**Sydney Western City Panel Meeting
1 October 2019**

Panel Reference	PPSSWC-8
DA Number	DA0235/18
LGA	Hawkesbury City Council
Proposed Development	Motel - Demolition of Existing Structures, Construction of a Two Storey Motel Building Containing 94 Rooms, Basement Car Parking and Landscaped Areas
Street Address	189 Windsor Road VINEYARD NSW 2765 (Lot 2 DP 1164124)
Applicant	Homeplan Architects
Owner	Swankin Pty Limited
Date of DA Lodgement	30/05/2018
Number of Submissions	14 submissions with original notification and 4 submissions with second notification
Regional Development Criteria (Schedule 7 of the State and Regional Development SEPP)	The development application has not been determined within 120 days and the application was referred to the Sydney Western City Panel under Clause 9 of Schedule 3 to State Environmental Planning Policy (State and Regional Development) 2011
List of all relevant Section 4.15 matters	<ul style="list-style-type: none"> • List of the relevant environmental planning instruments under Section 4.15(1)(a)(i): <ul style="list-style-type: none"> - State Environmental Planning Policy (Infrastructure) 2007 - State Environmental Planning Policy (State and Regi

Image 3 - Extract form flood extent map. (Blue area showing land below the 1 in 100 year flood event)

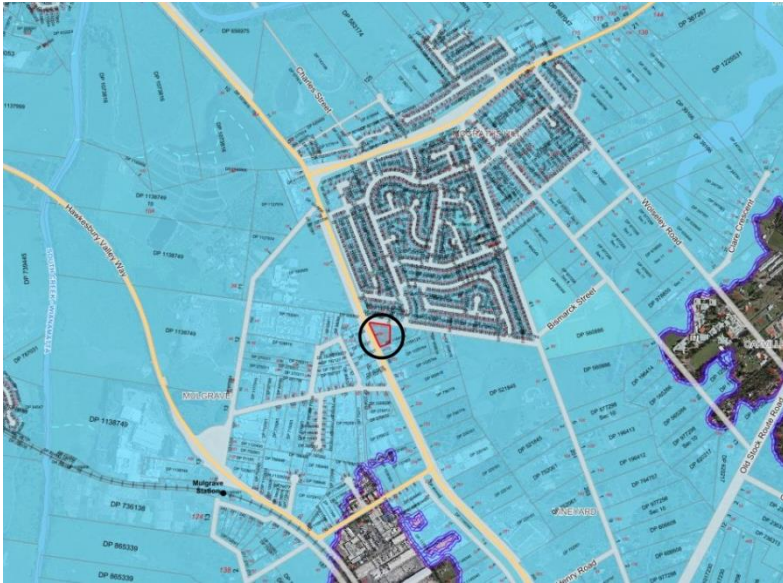
It is considered that the justification provided in relation to proposed motel does not demonstrate that the development is acceptable having regard to the objectives of Clause 6.3 of the LEP which seek to minimise the flood risk to life and property associated with the use of land; allow development on land that is compatible with the land's flood hazard and avoid significant adverse impacts on flood behaviour and the environment.

The application is not supported by any site specific flood assessment and support of the proposal based on the justification would result in setting an undesirable precedent for increasing the development of flood prone land. Clause 6.3 (3) prevents the consent authority from granting consent to development below the flood planning level unless the consent authority is satisfied that the development:

- the application proposes a substantial intensification of development on flood liable land without considering the flood hazard of the land in terms of floodwater depth and floodwater velocities affecting the proposed building,

- the application is not supported by details or assessment in relation to how floodwaters would be kept outside of the proposed basement, how floodwaters will change as a consequence of the proposed building, how floodwaters would impact the proposed onsite effluent disposal system or how the proposed building could be designed to withstand the forces of floodwater, debris, and buoyancy up to the 1:100 ARI event,
